ADDENDUM TO THE CONTRACT DOCUMENTS

ADDENDUM NO. 002
	Project: Solano Community College District Fairfield Campus Early Learning Center Project Project Number: 23-003
	Date: September 20 th , 2022

Addendum No. 002 – The following clarifications are provided and must be added/considered when completing your bid: Acknowledgement of receipt of this **Addendum No. 002**, is required on the Bid Form. Please clearly note the addendum date and number.

L3.1

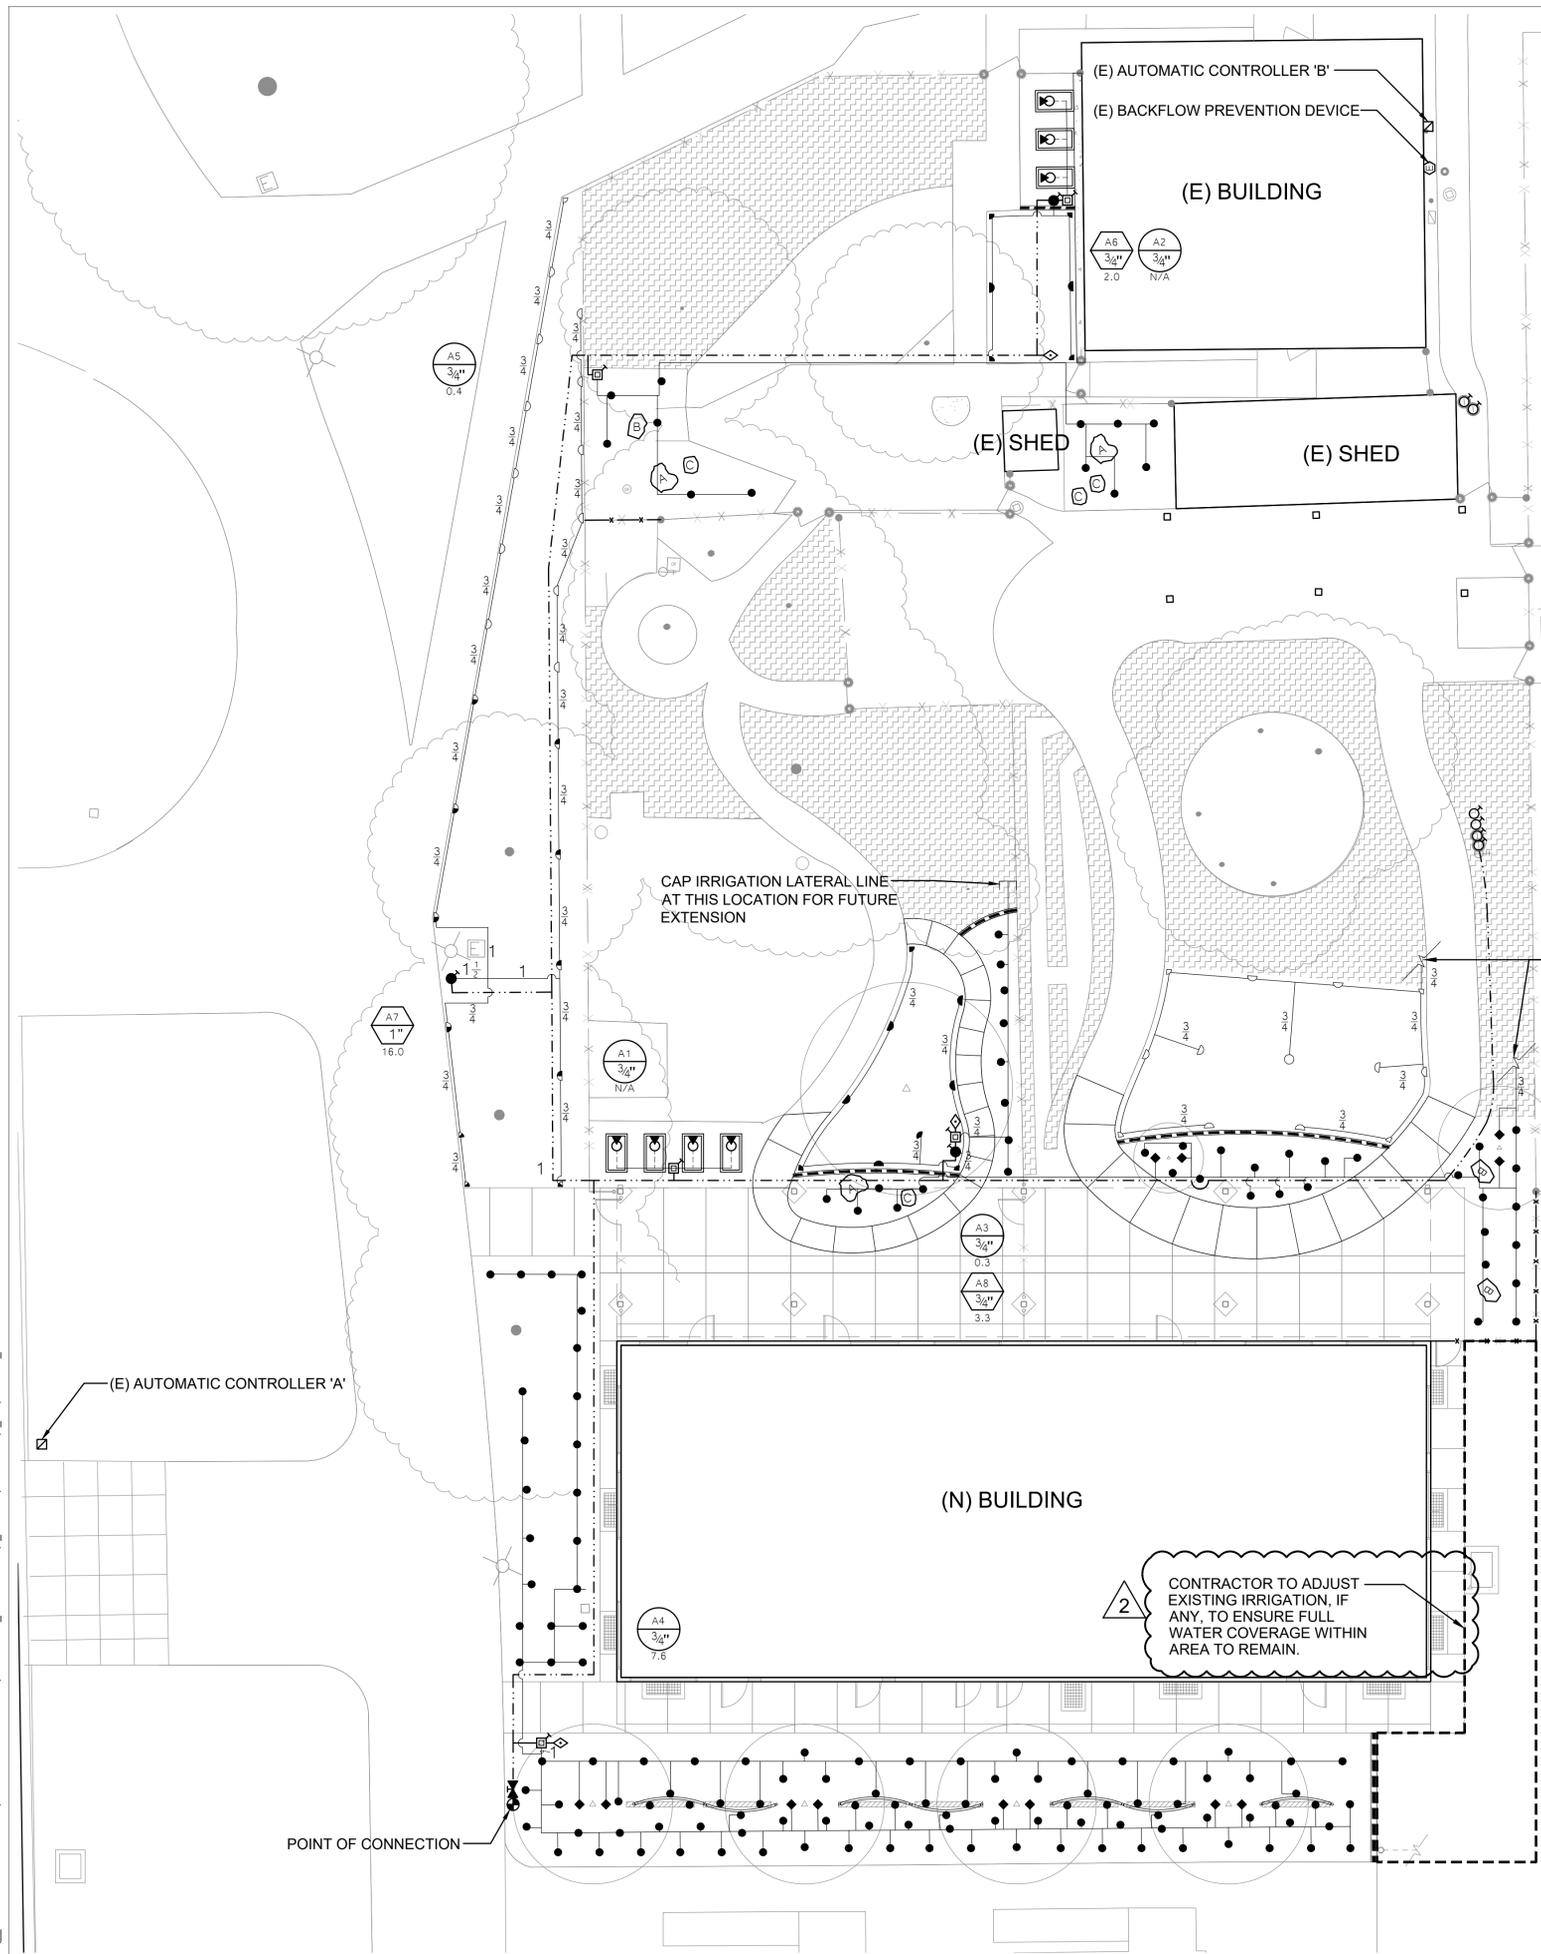
Question: Refer to sheet L3.1, sprinkler irrigation legend, symbol for automatic control valve is different from symbol shown on plan. Please clarify.

Question: Please provide irrigation design for existing lawn area shall be repaired with new sod located along new building on sheet L3.1.

Response: *The symbols on the legend for the automatic control valve are shown on the plans. There is nothing to clarify.*

Response: *The existing lawn irrigation head spacing and types are unknown. Contractor to budget an allowance to repair as needed to ensure proper irrigation coverage.*

8 VINE PLANTING DETAIL

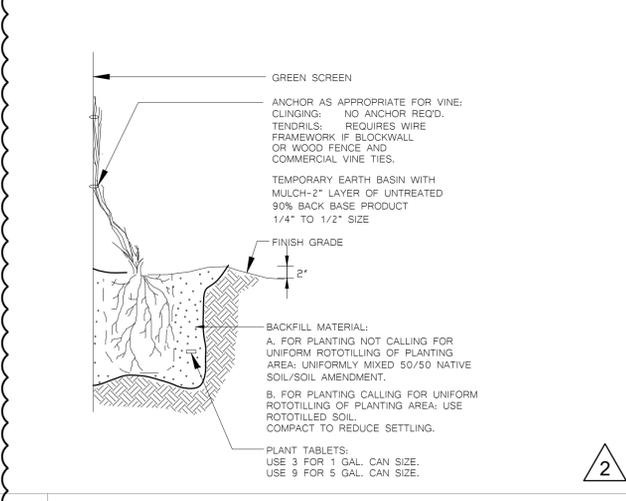
Question: Please provide detail of vines

Response: *Vine installation detail provided in Addendum 2.*
